INSPECTION REPORT

INSPECTION DATE & TIME: June 13, 1988
7a.m. to 4:30p.m.

Permittee and/or Operators Name: Genwal Coal Company
Business Address: P.O. Box 1201, Huntington, Utah 84527
Mine Name: Crandall Canyon Permit Number: ACT/015/032
Type of Mining Activity: Underground XX Surface Other
County: Emery
Company Official (s): Andy King and Lannie Burnside
State Official(s): Harold G. Sandbeck
Partial: Complete: XX Date of Last Inspection: May 12, 1988
Weather Conditions: Clear and cool
Acreage: Permitted 164.4 Disturbed 5.75 Regraded 0.5 Seeded 0.5 Bonded 5.75
Enforcement Action: None

CRANDALL CANYON MINE

PLATE 7-5

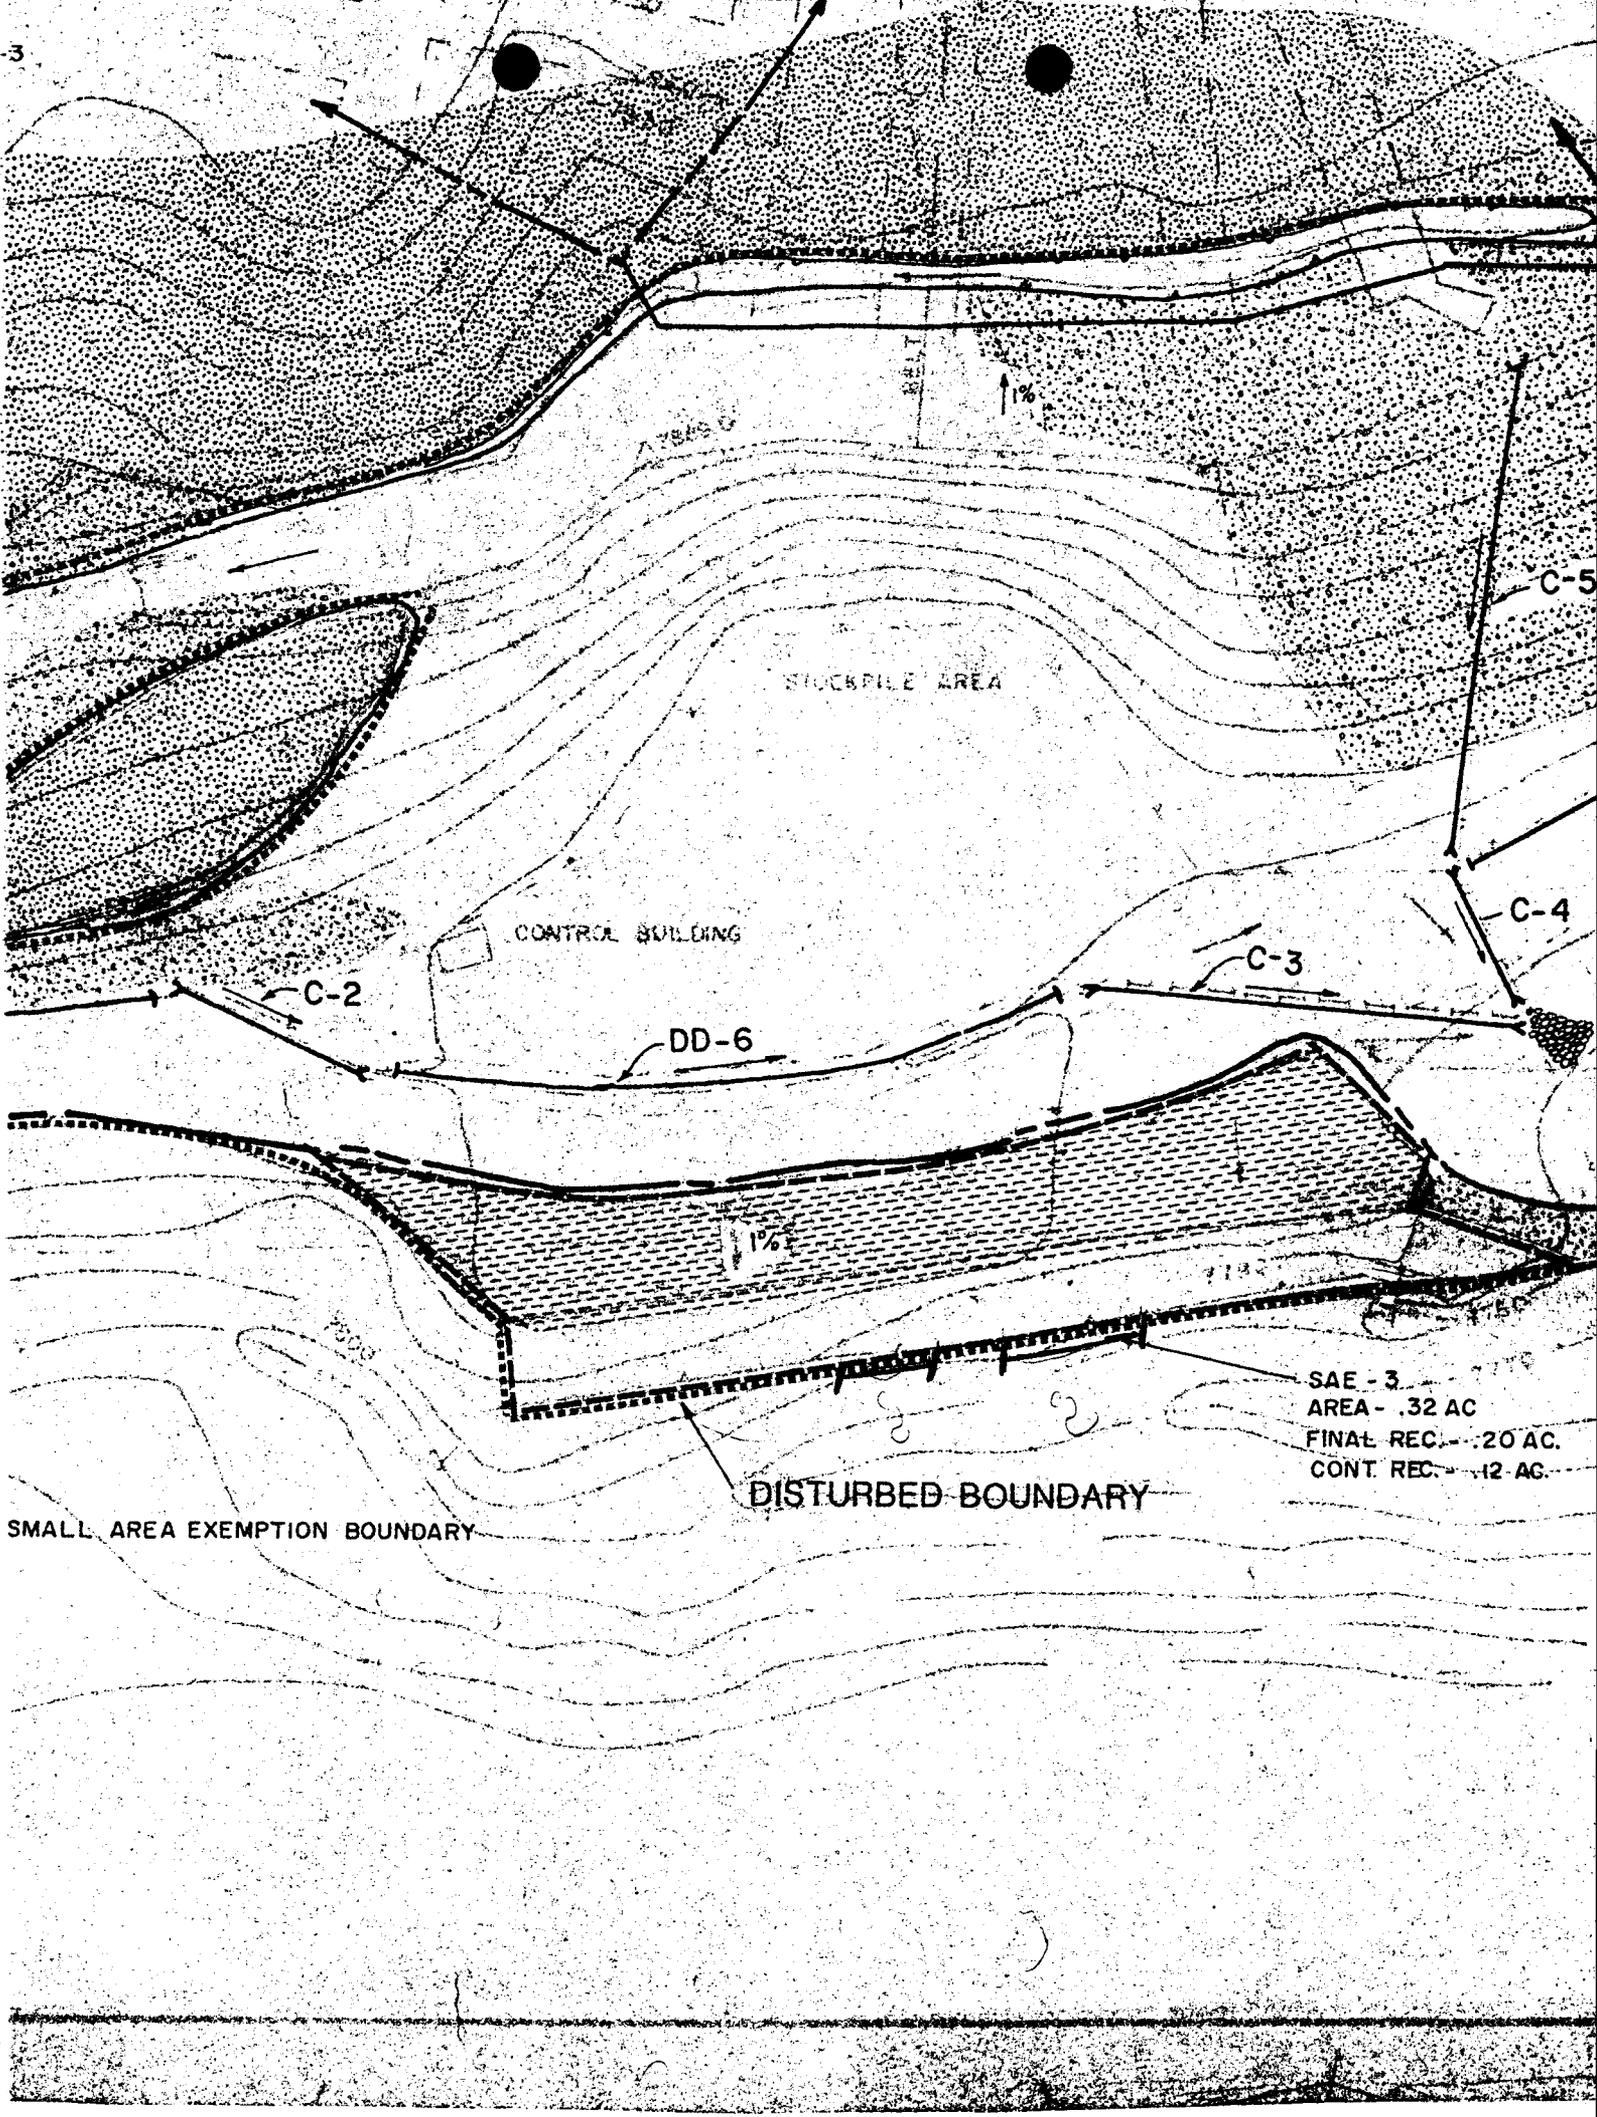
- * In small area exemptions (SAE) 1 and 2, the operator was informed on the removal, installation and/or replacement of silt fencing. For the location of SAE 1 and 2, see Plate 7-5. During this complete inspection, the undersigned inspector located the silt fences in SAE 1 and 2 on a map which will be attached to this report. The locations are not exact and the operator must submit revised maps during the permit renewal review. The operator was informed to properly secure and key in all silt fences.
